Clio II

62 NEW VERSION OF PASSENGER COMPARTMENT FAN SPEED RESISTOR UNIT

- Engine: **XXX**
 - Gearbox: **XXX**
- Basic manual: M.R. 337**

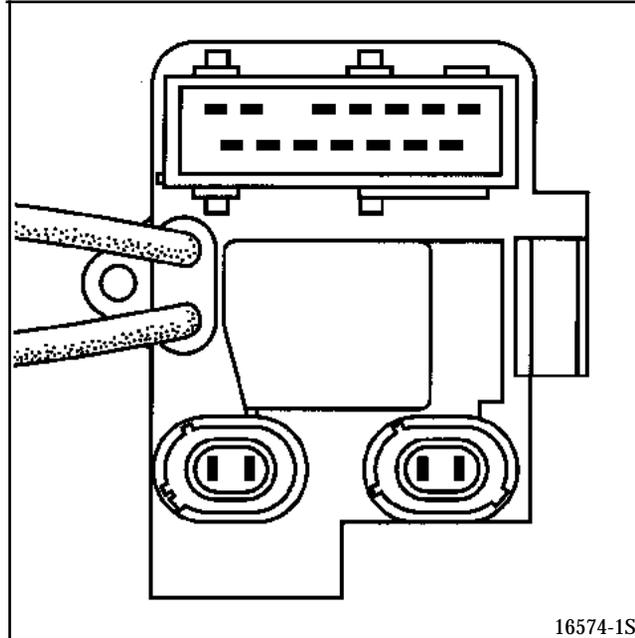
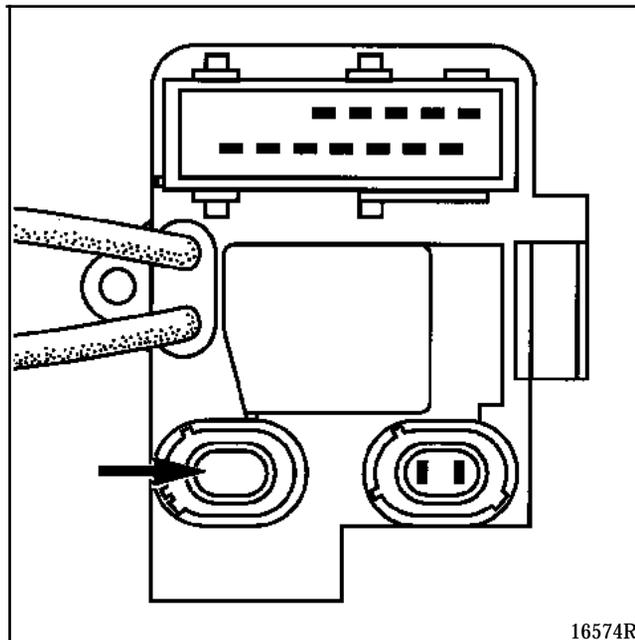
Resistor unit with evaporator sensor as fitted until
15 June 1998.

Resistor unit without the evaporator sensor
connector for air conditioning, as fitted in vehicles
after 15 June 1999.

The new computer management system no longer recognises evaporator sensor information for the air conditioning system.

If any work is carried out which requires the replacement of the resistor unit on vehicles which left the factory before 15 June 1998, the computer needs to be reprogrammed.

Connect the diagnostic equipment.

NXR	XR25
Select dialogue mode with the computer. "Computer configuration" command. "Configuration without evaporator sensor" command, line 4912 (evaporator sensor).	Enter code D17 to select the mode to communicate with the computer. Enter code G49*12* for the configuration "without the evaporator sensor" (evaporator sensor).
